ATTACHMENT B

Proposed changes to Technical Specifications of Facility Operating License NPF 72 and 77:

1. Braidwood Station Onsite Review
2. BwAP 1205-3T3, Request for Offsite Review
3. Revised pages:

FIGURE 3.4-2a  
REACTOR COOLANT SYSTEM HEATUP LIMITATIONS  
APPLICABLE UP TO 32 EFY (UNIT 1)

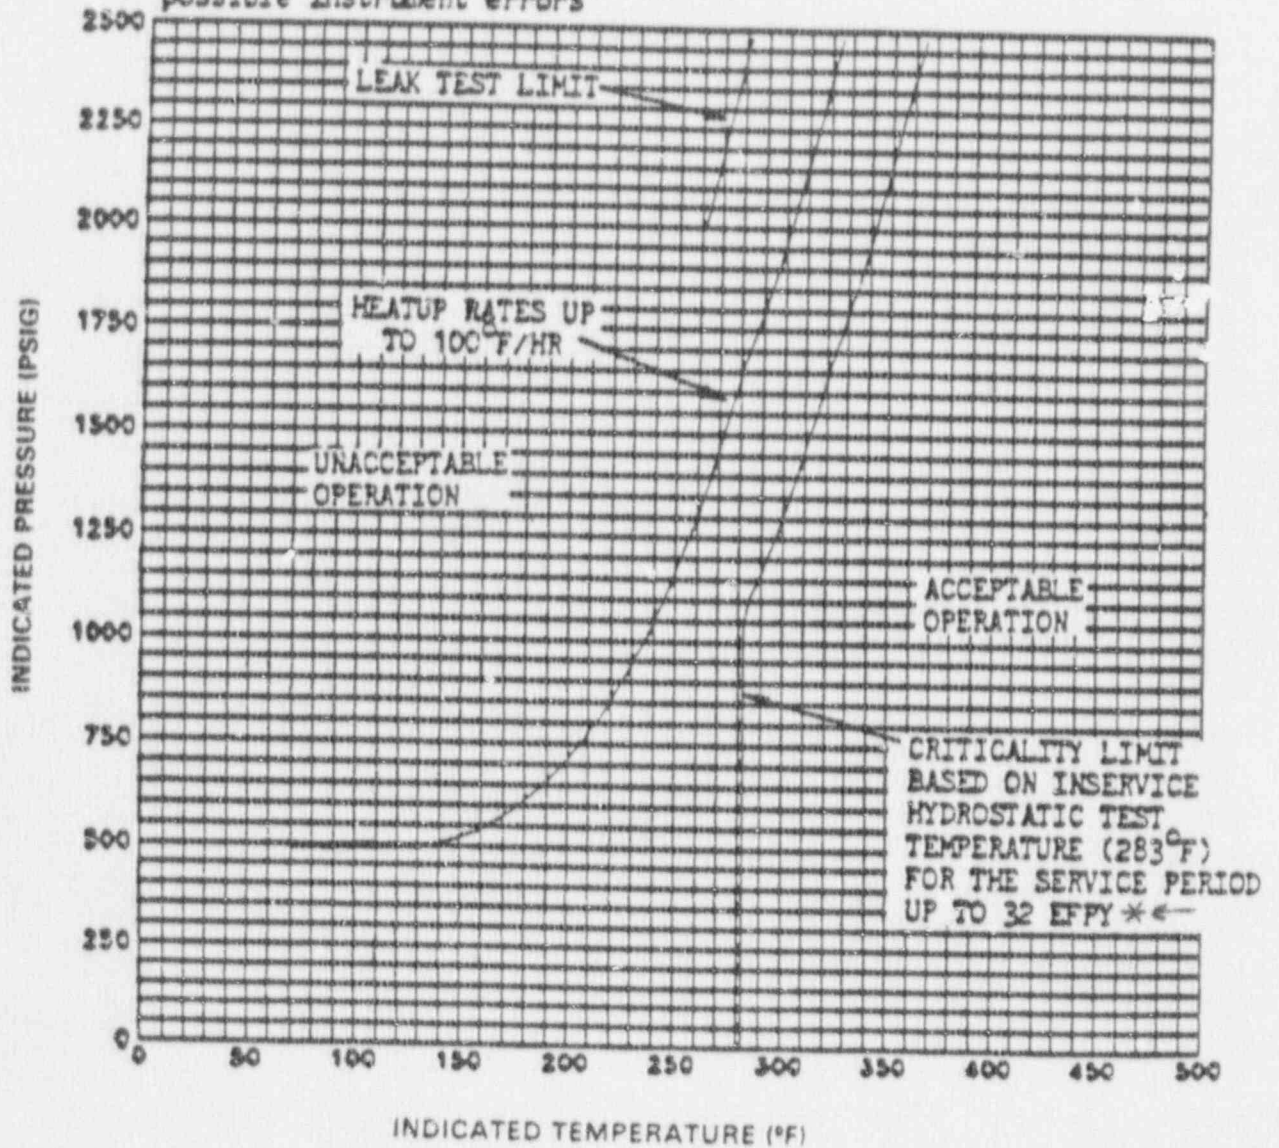
\* applicability date has been reduced per Regulatory Guide 1.99 Revision 2 to 4.5 EFY. The calculation to determine applicability utilized actual copper content of 0.05 wt%.

FIGURE 3.4-2b

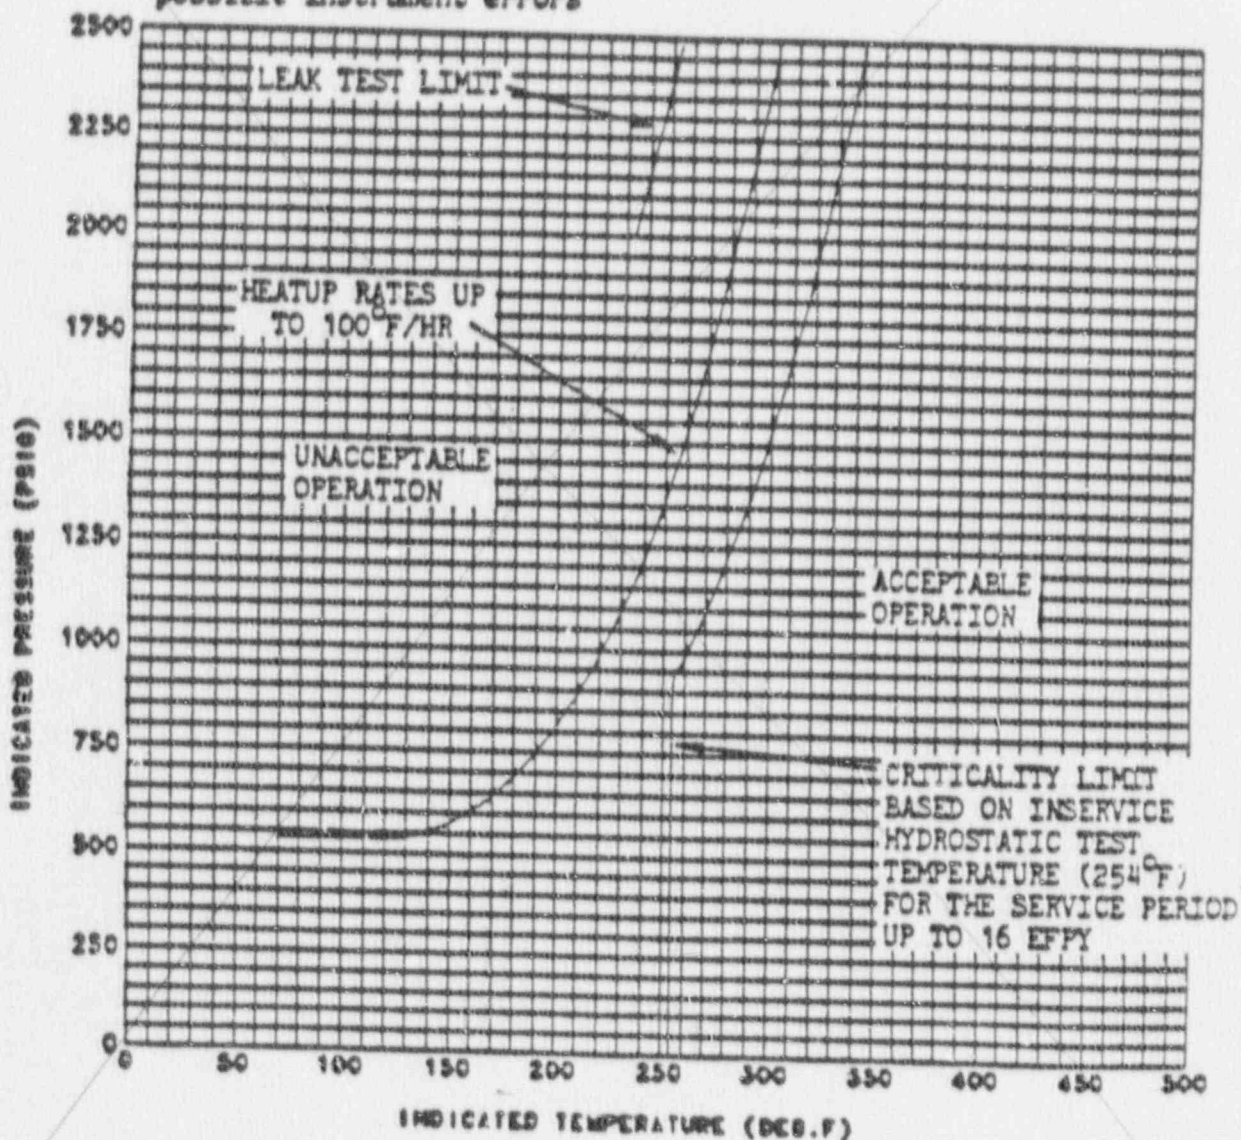
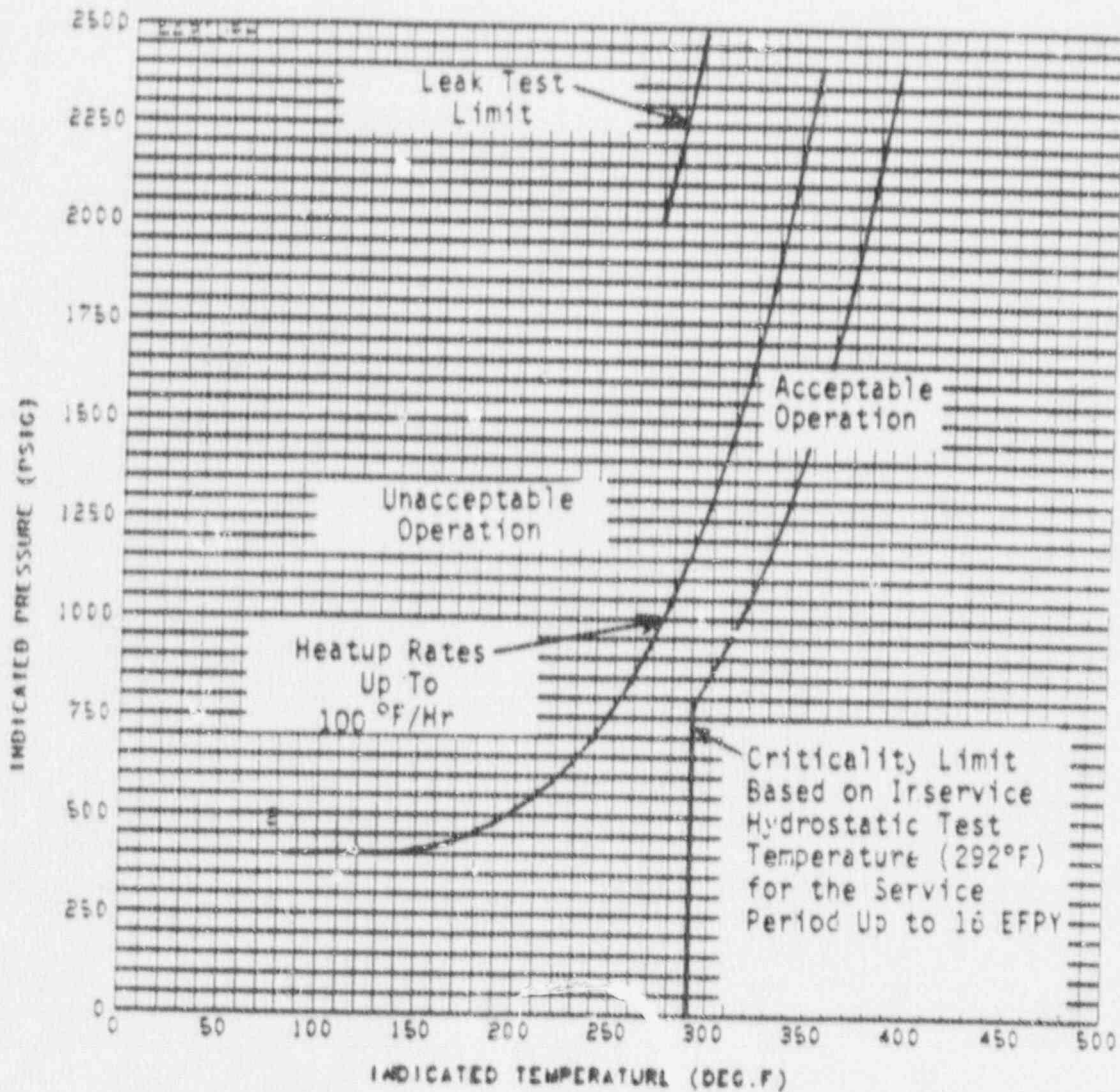
Replace with new figure 3.4-2b.

New Flange  
3.4.2b

FIGURE 3.4-3a

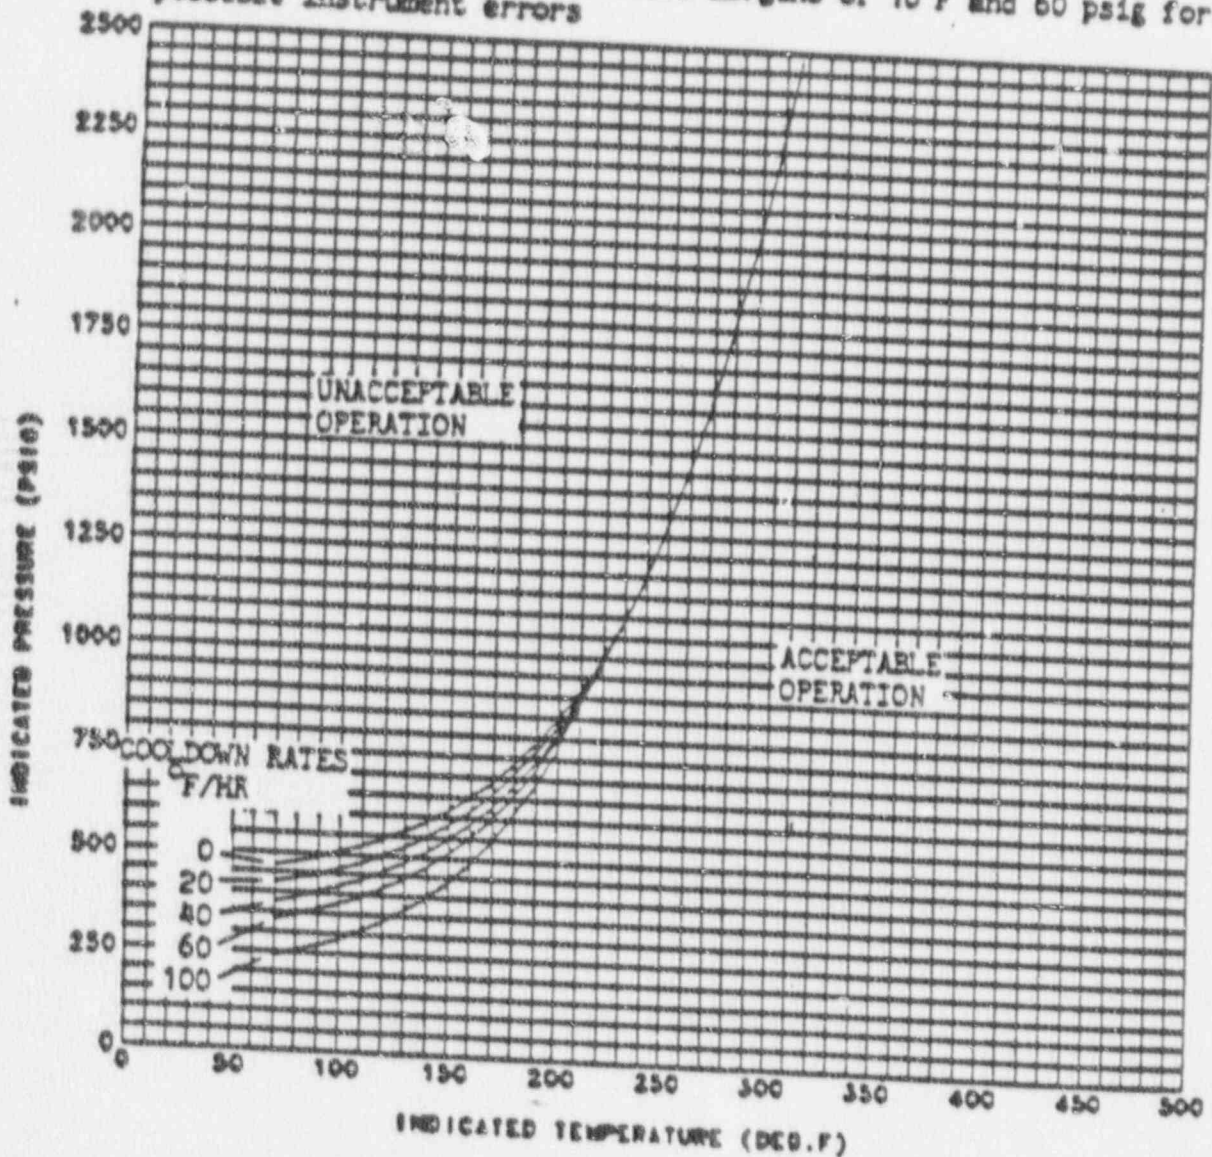
\* applicability has been reduced per Regulatory Guide 1.99 Revision 2 to 12 EFPT. The calculation to determine applicability utilized actual copper content of 0.05 wt%.

FIGURE 3.4-3b

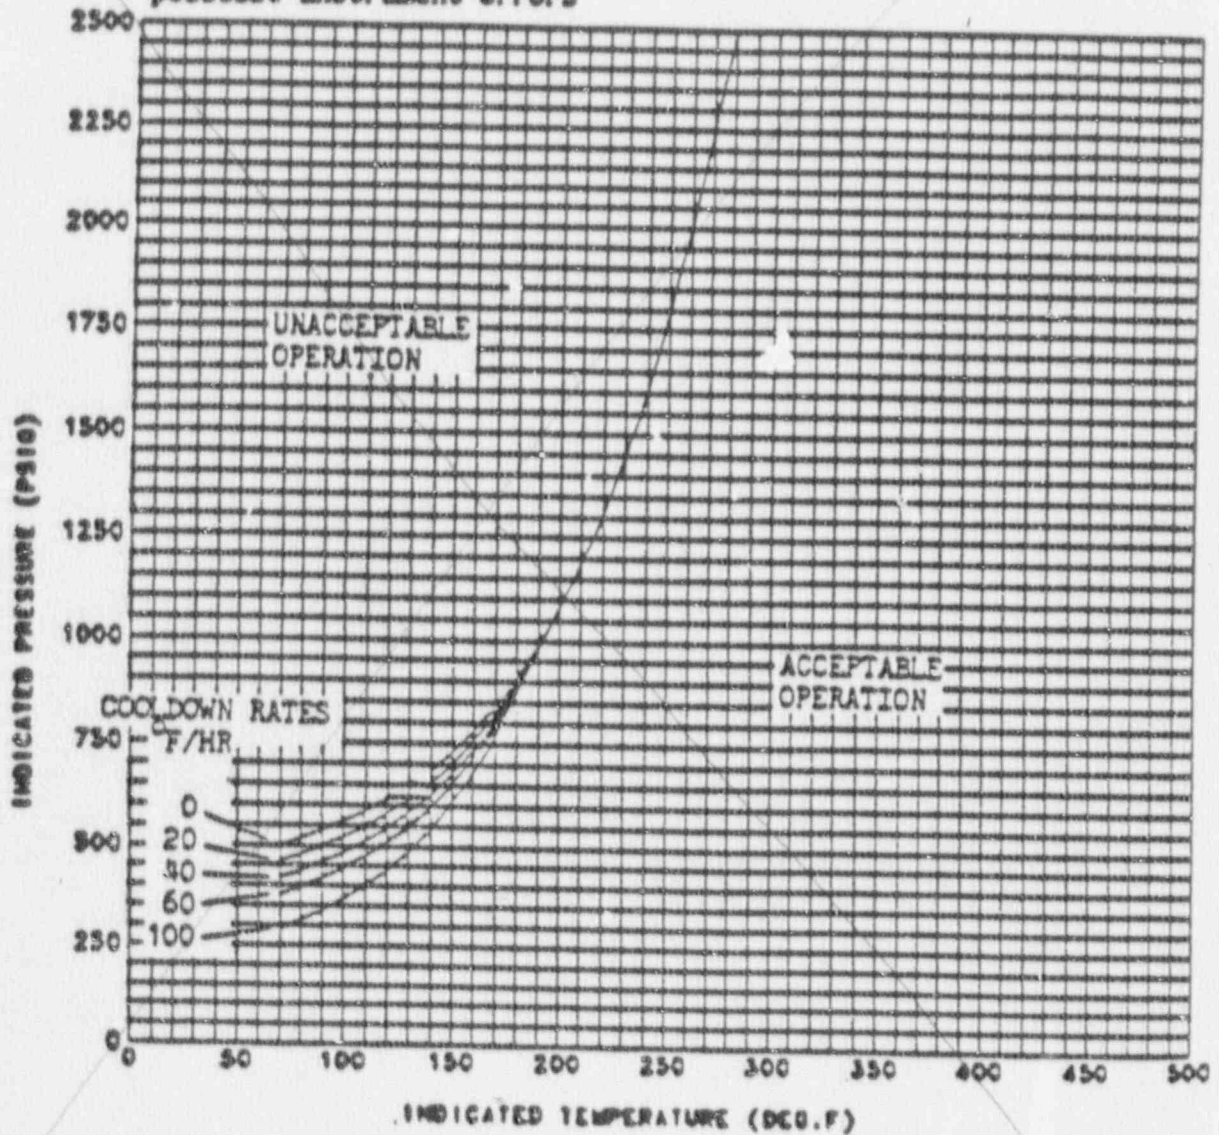
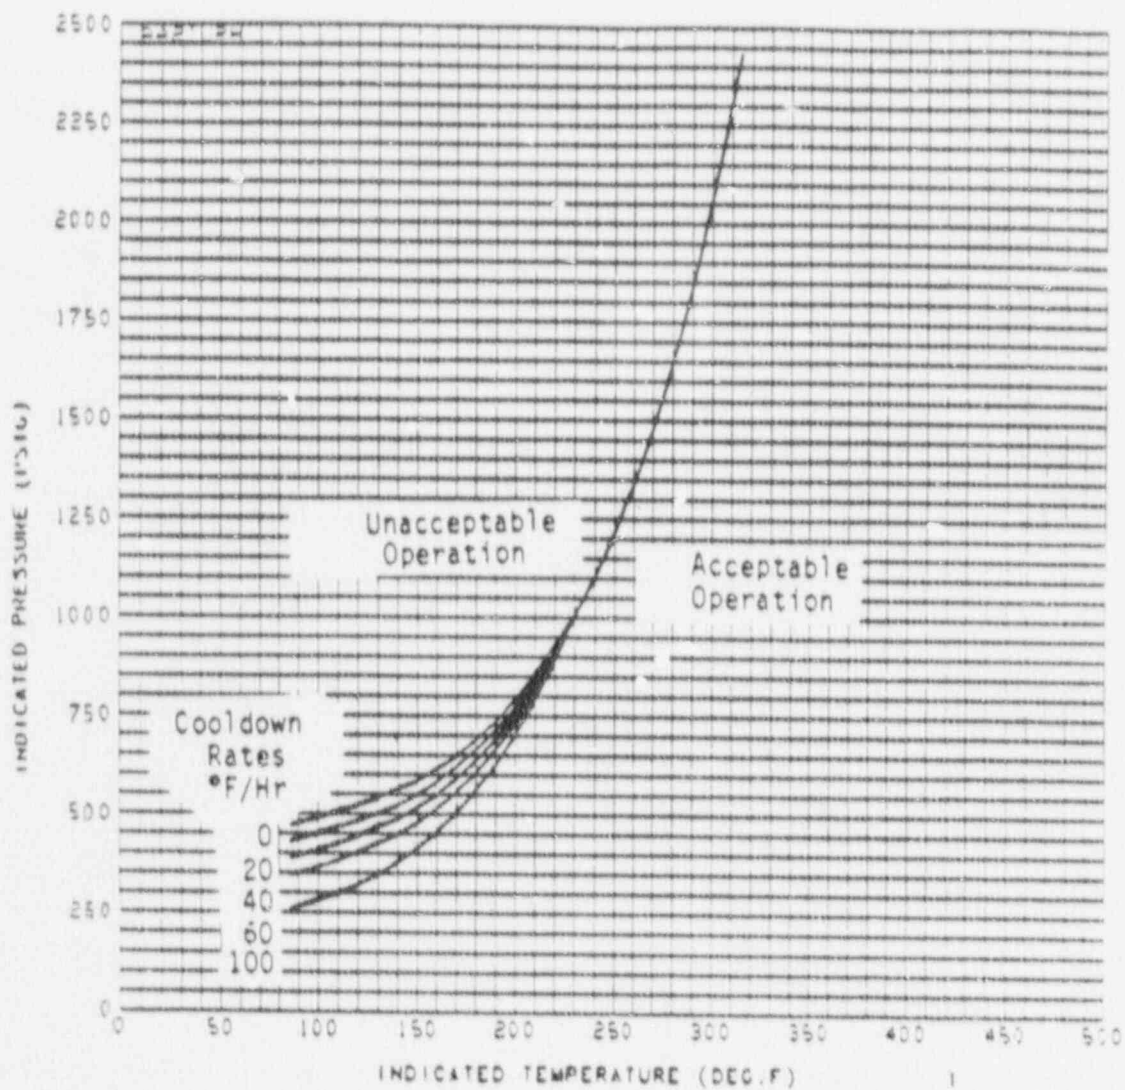
Replace with new  
figure 3.4-3b

New Figure 3.4-3.6

FIGURE 3.4-4a

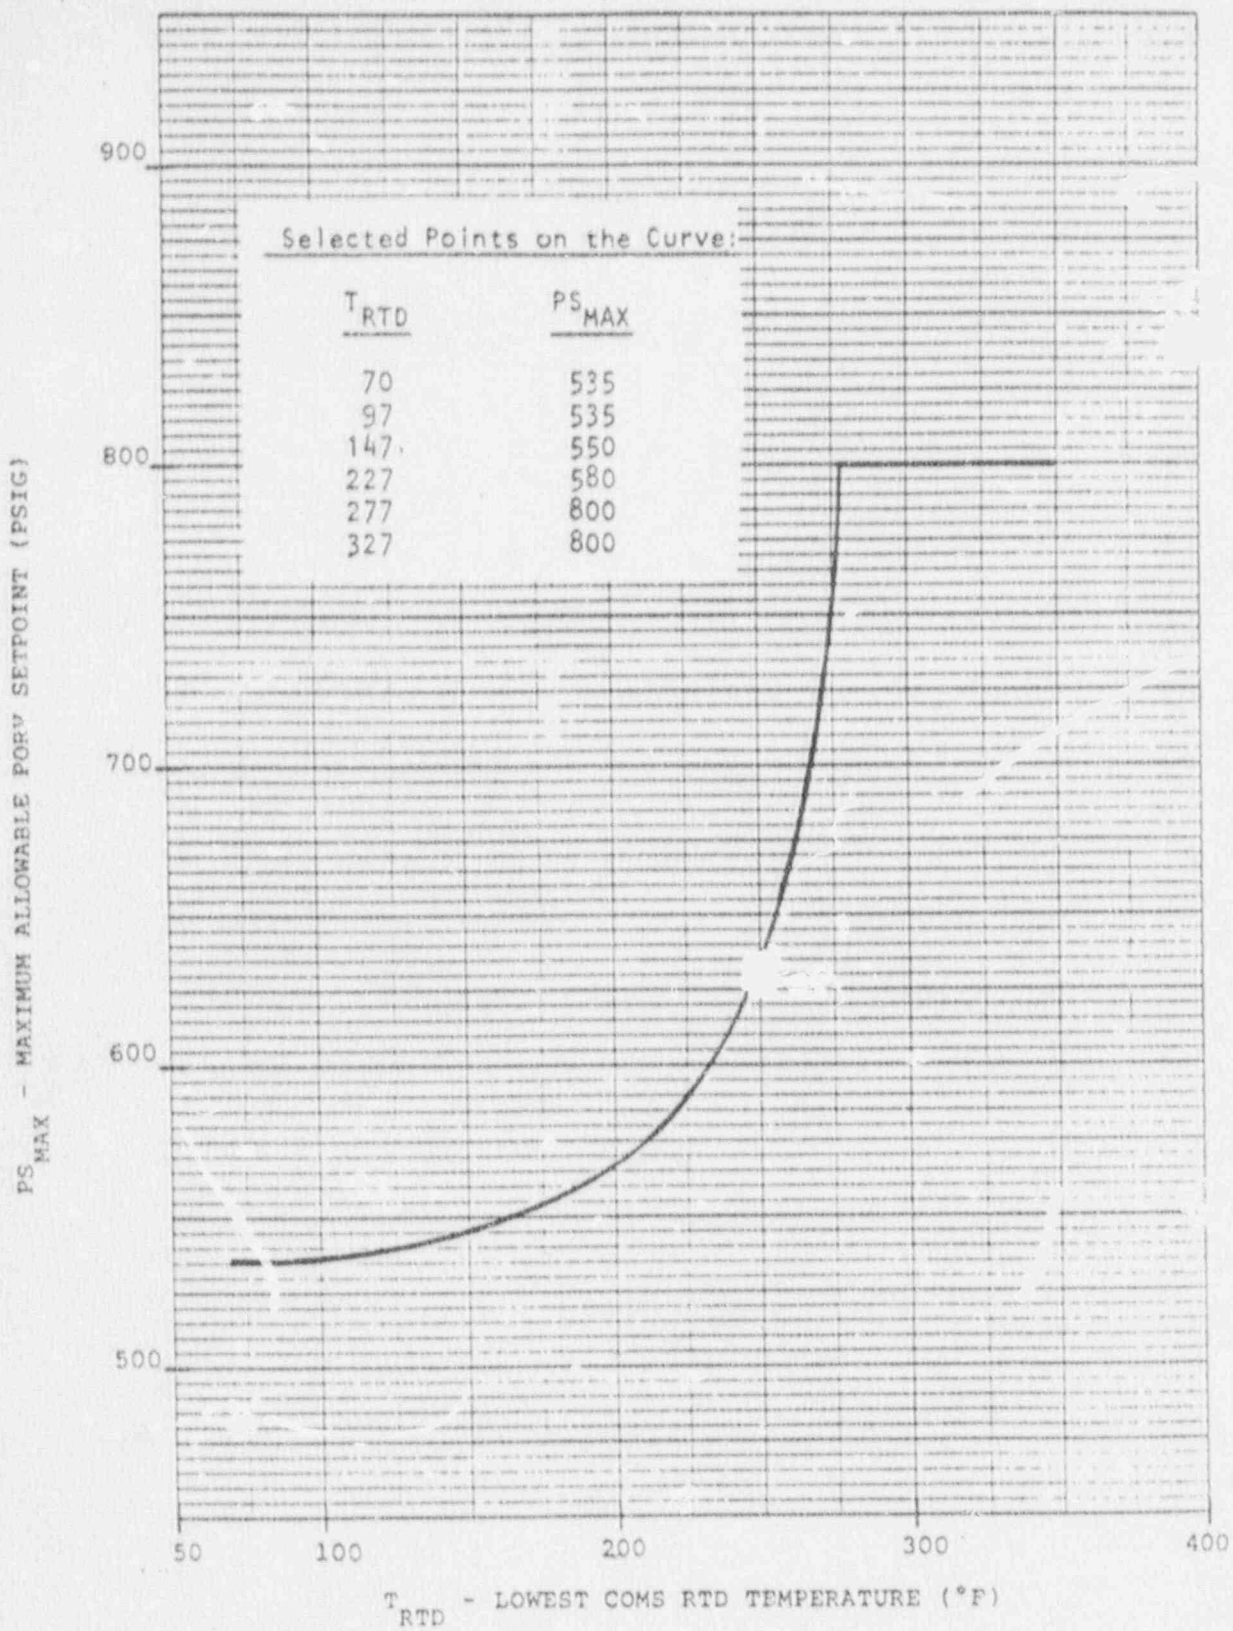
\* Applicability has been reduced per  
Regulatory Guide 1.99 Revision 2 to 4.5 EFY. The  
calculation to determine applicability utilized actual copper  
content of .05%.
